# HISTORIC AND DESIGN REVIEW COMMISSION

**HDRC CASE NO:** 2018-139  
**ADDRESS:** 712 LAMAR ST  
**LEGAL DESCRIPTION:** NCB 1653 BLK A LOT E 50 FT OF 1&2  
**ZONING:** R-5  
**CITY COUNCIL DIST.:** 2  
**DISTRICT:** Dignowity Hill Historic District  
**APPLICANT:** Konda Pulley  
**OWNER:** Konda Pulley  
**APPLICATION RECEIVED:** March 22, 2018  
**60-DAY REVIEW:** May 21, 2018

The applicant is requesting a Certificate of Appropriateness for approval to install a metal gazebo at the rear of the property.

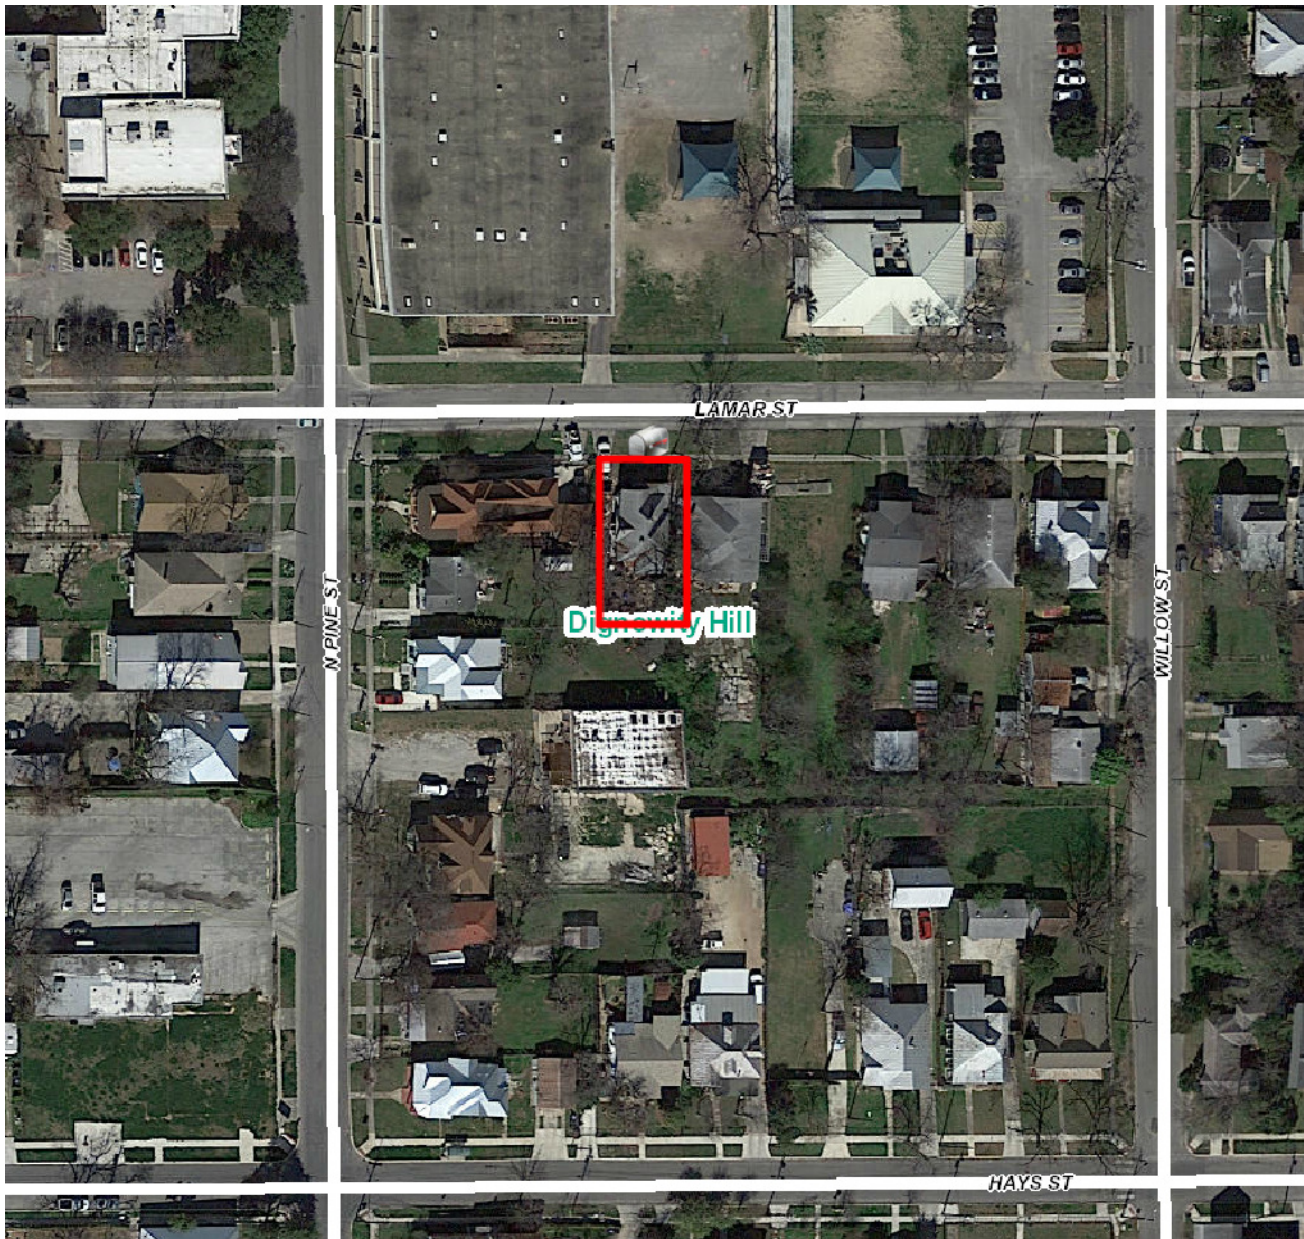
- c. GAZEBO – Per the application documents, the applicant will install the proposed gazebo on a concrete slab that is to feature a total of 115 square feet in size. Additionally, the proposed gazebo will feature panels that are six (6)

feet in height and approximately five (5) feet in width. The metal columns are to be approximately seven (7) feet in height. Generally, staff finds the proposed gazebo appropriate given that due to its location it will not be easily seen from the public right of way.

Staff recommends approval as submitted based on findings a through c.
